**AGENDA**  
**PLANNING AND ZONING COMMISSION WORK SESSION**  
**City Hall, 385 South Goliad, Rockwall, Texas**  
**Council Chambers**  
**June 25, 2019**  
**6:00 P.M.**

**MINUTES**  
**PLANNING AND ZONING COMMISSION WORK SESSION**  
**City Hall, 385 South Goliad, Rockwall, Texas**  
**Council Chambers**  
**May 28, 2019**  
**6:00 P.M.**

**EAST ELEVATION**

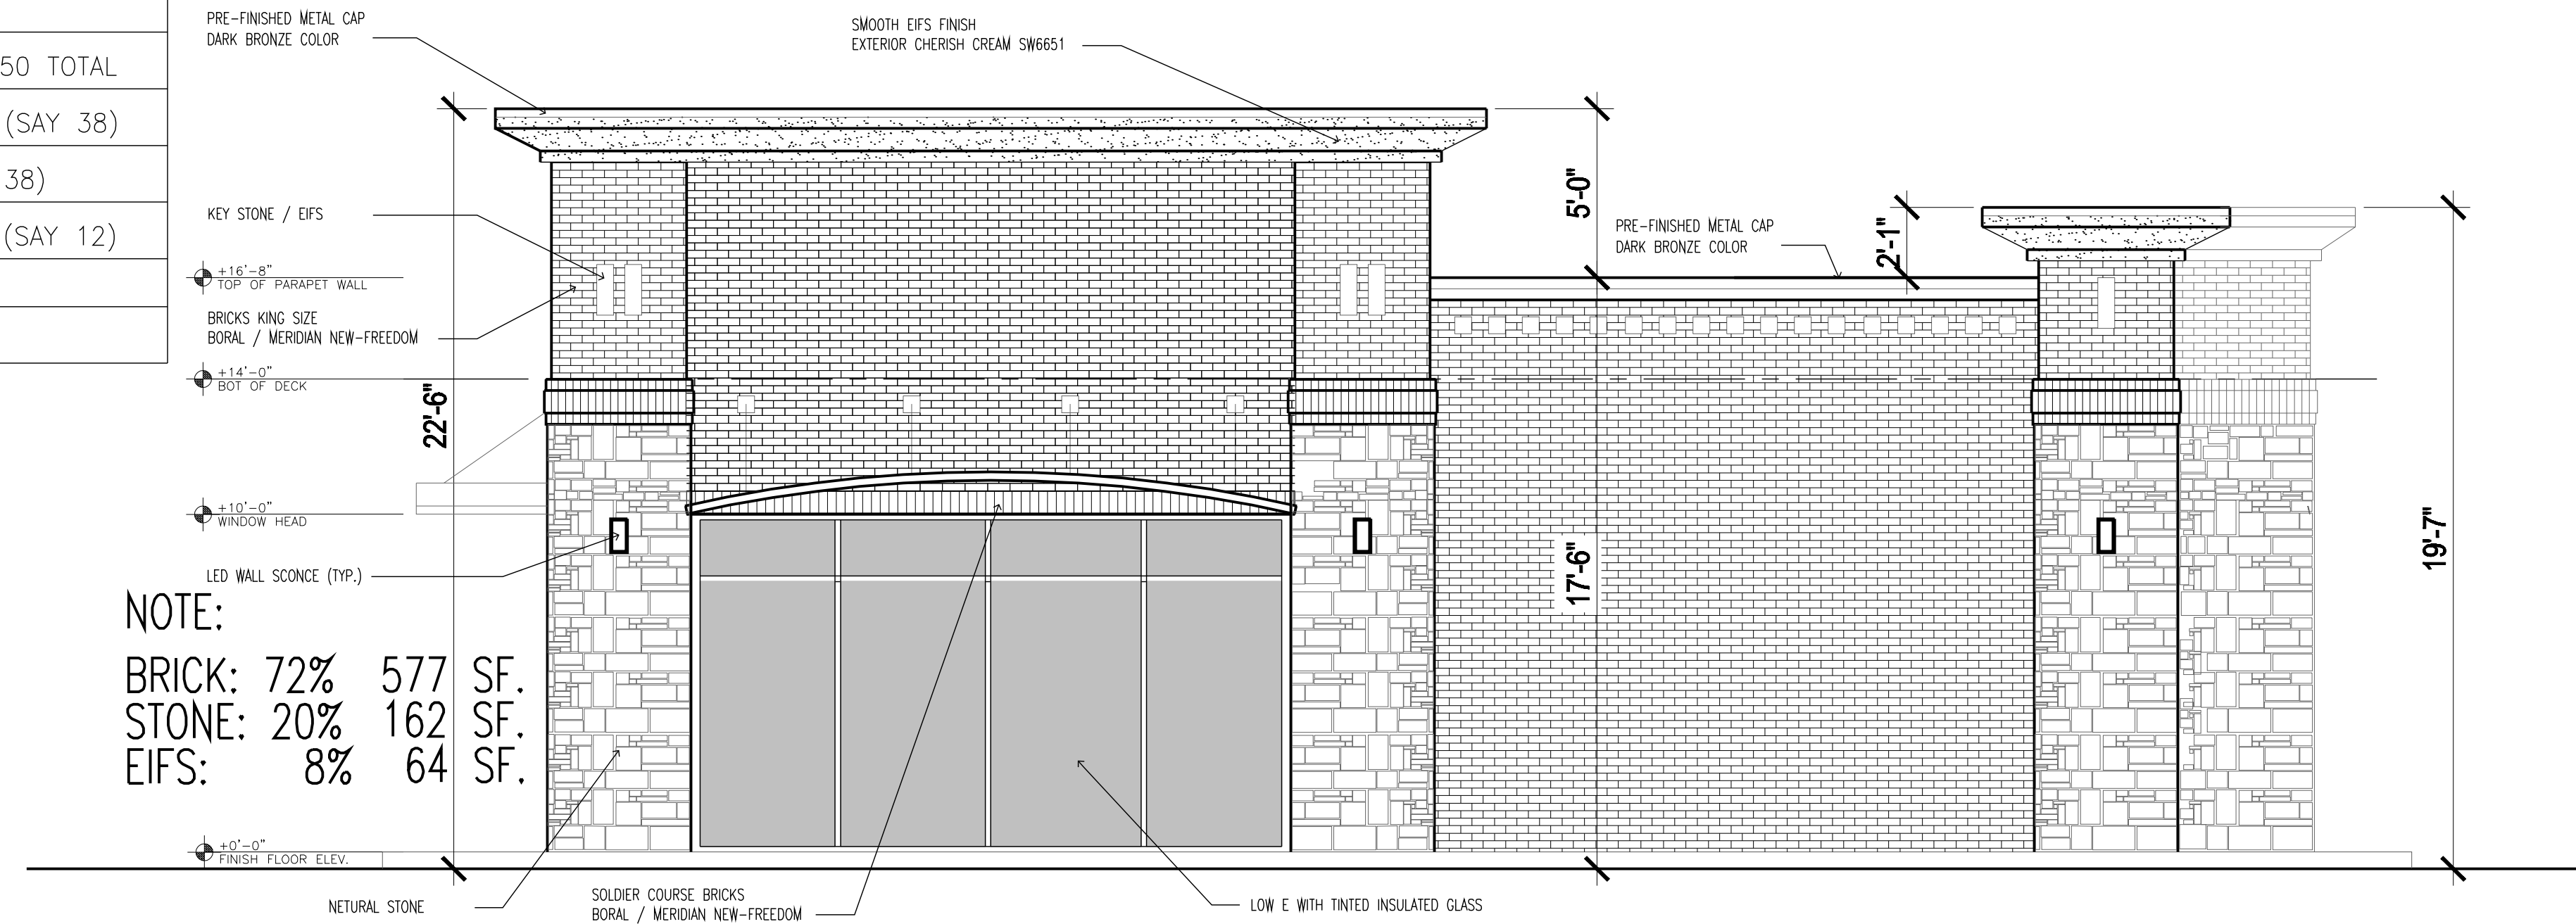
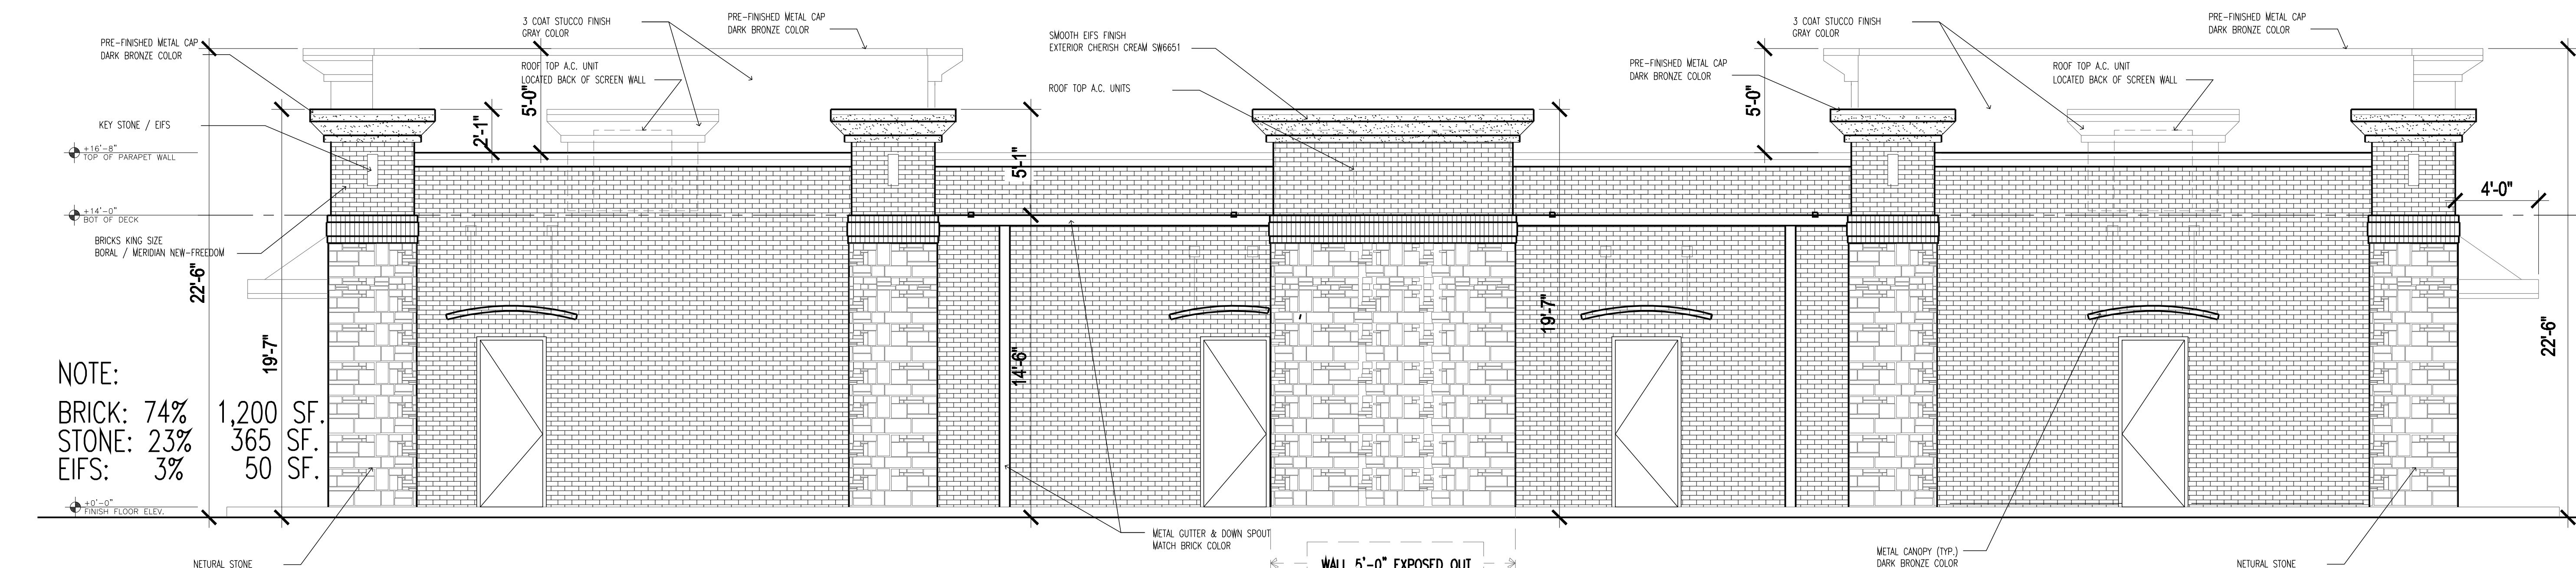
71. Sheet A502—Please see comments from A501						
72. Sheet A502—Please note that as drawn, the rear elevation will need several variances: vertical and horizontal articulation, 4 sided architecture, 20% stone requirement.

73. Sheet A502—There are three vertical lines drawn between the doors. What are these lines?						
74. Sheet A502—Please label the element directly on top of the brick.

75. Sheet A502—Please note, the back of the parapets is visible. The back of the parapets will need to be finished and revised so that it is not a flat parapet (i.e. it will need to look like a “box” rather than a “panel”

76. Sheet A502—Please provide a perspective drawing.						
77. Sheet A201—Please note that this sheet is for reference and was not reviewed or approved. That will be taken care of at time of Building Permit submission.

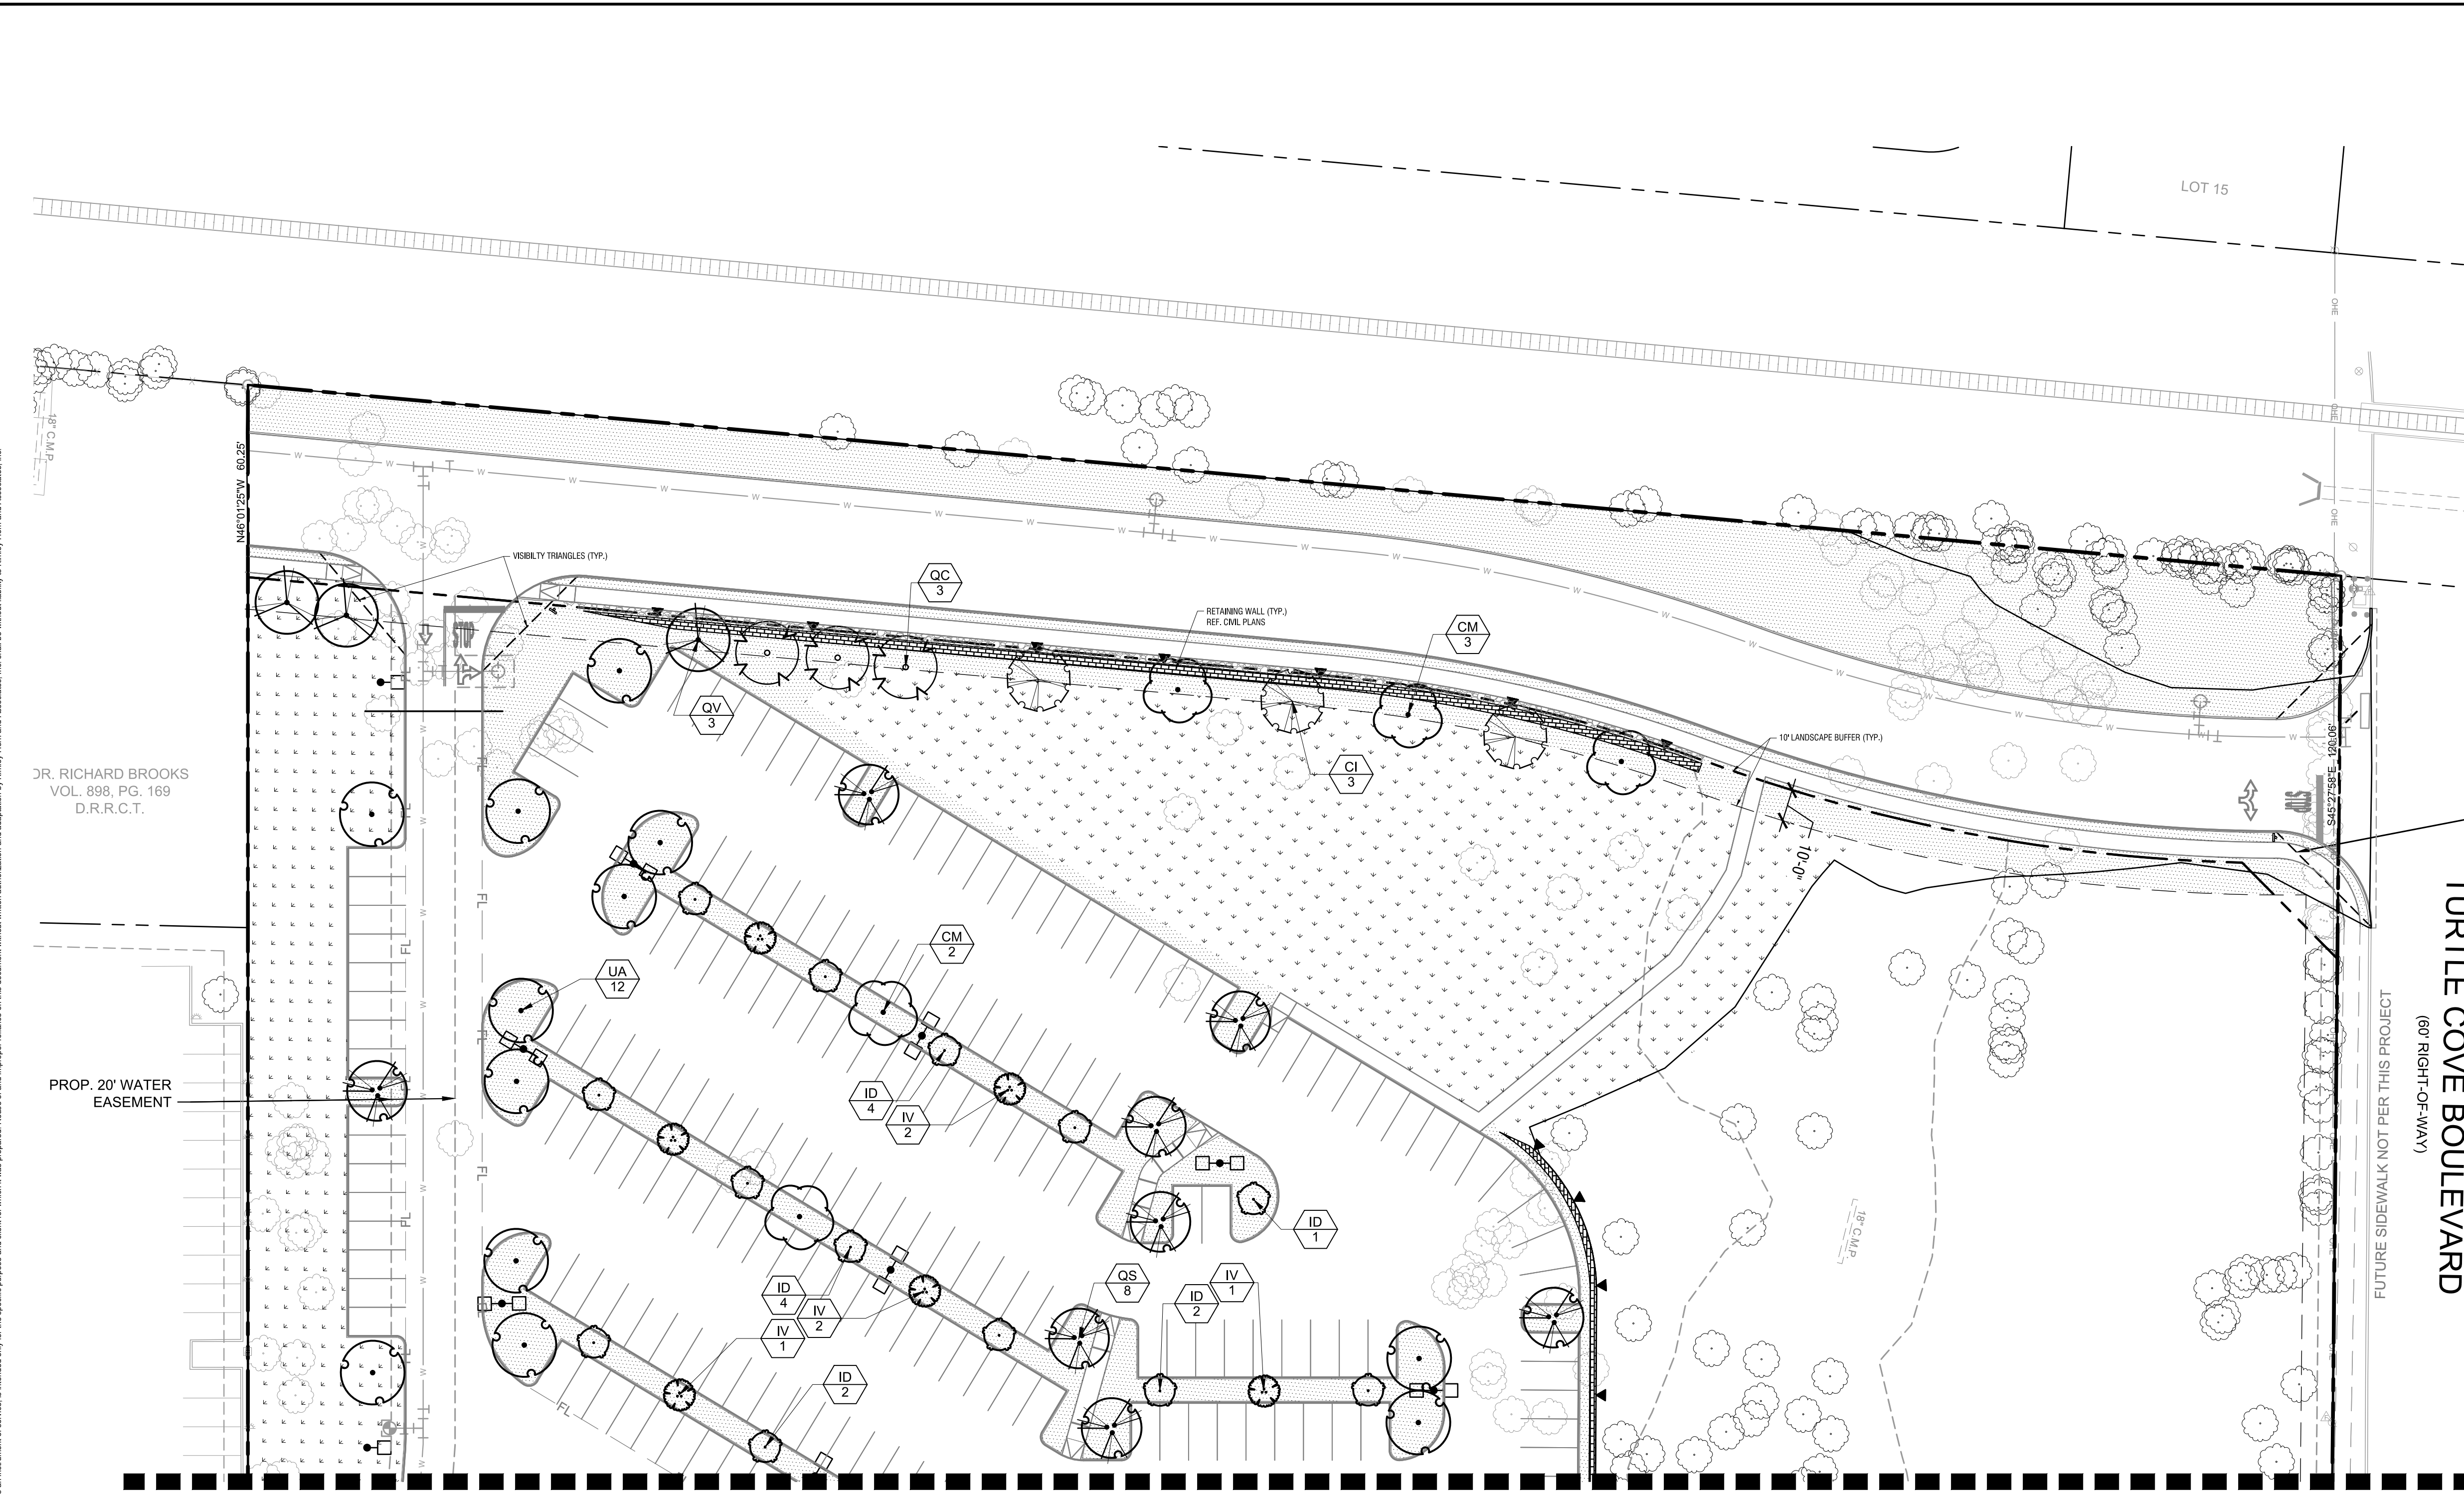
5. Planting Plan Sheet LP 1.01: Correct table to indicate minimum 20-ft Landscape Buffer for Scenic Overlay(Ridge Road).
						6. Planting Plan Sheet LP1.01: Correct table to indicate a minimum of two(2), four (4)-caliper inch trees (i.e. 7 trees) & four (4) accent trees (i.e. 13) per 100 linear feet within the 20-ft Landscape Buffer (Scenic Overlay District Standard).
						Treescape Plan:
